**Sydney Metro Northwest Places Program  
Tallawong Station Precinct South  
SSD 9063**

**Submissions Report**

**October 2018**

**Figure 4:** Typical development floor heights (floor to floor) under Concept Proposal showing adherence to ADG requirements for ground and first floors

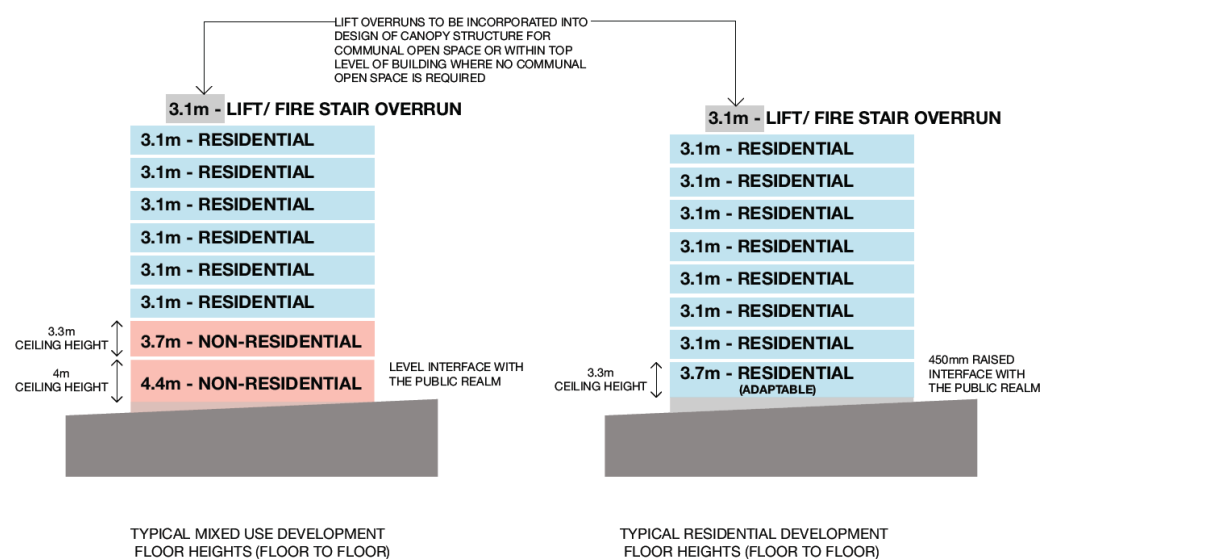
- the proposed quality and quantity of commercial floor space and the implications for building heights and overall strategic planning objectives for the project
- clarification sought regarding floor to floor ceiling heights
- compliance with the Apartment Design Guide.

To accommodate the retail/commercial floorspace, the ground and first floor of buildings in the B4 Mixed Use zone will have higher floor to floor heights than the residential levels above. The floor to floor height of the ground level is proposed at 4.4 metres (allowing for provision of cafes/restaurants) and 3.7 metres on the first floor (floor to ceiling height of 4 metres and 3.3 metres respectively). This accords with the recommendations in the Apartment Design Guide (ADG).

Provision is also made for 3.7 metre floor to floor ceiling heights (floor to ceiling height of 3.3 metre) on the ground floors of building 1B.3 and buildings in the R3 zone to provide for maximum flexibility of ground floor uses in the future, in accordance with the design guidance requirements of the ADG.

The proposed floor to floor heights correspond with the objective in the ADG that the ground and first floor levels of mixed use apartment buildings should have increased ceiling heights to ensure their longer term adaptability for other non-residential uses such as offices and shops. This is shown in Figure 2 and Figure 3 (Figures 4C.1 and 4C.2 of the ADG) on the following page.

The Concept Proposal has adopted the ADG recommendations, as shown in Figure 4.

**Figure 5:** Comparison of original concept for park and retail plaza with new concept providing for enlarged park and relocated plaza

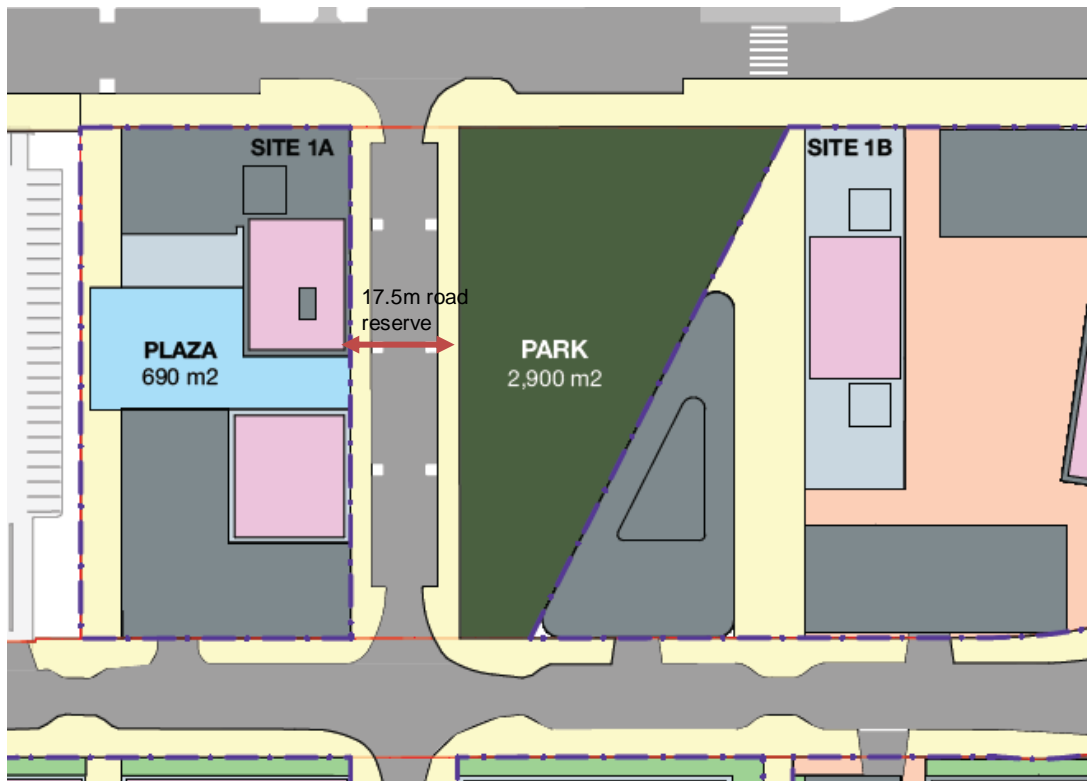
The Department also requested further detail on how the design excellence process would be implemented at future DA stages.

To provide improved solar access to the public domain, a number of changes have been made to the Concept Proposal. These are listed below.

- **Village park** - The park area has been increased from 2,900m<sup>2</sup> to 3,411m<sup>2</sup> (see Figure 6) with the expanded area of parkland receiving good solar access. This is in addition to the original park area which already receives sunlight to an area greater than 50% of its site area between 11 am and 2 pm on 21 June.

- **Retail plaza** – The retail plaza has been relocated to the eastern side of Building 1A.2 to provide for improved solar access and amenity. The relocation means there will be a strong visual connection and pedestrian interface between the park and the retail plaza. The overall result will be a significantly improved public domain experience.

Figure 5 compares the original concept for park and retail plaza with the new concept of the enlarged park and relocated plaza.
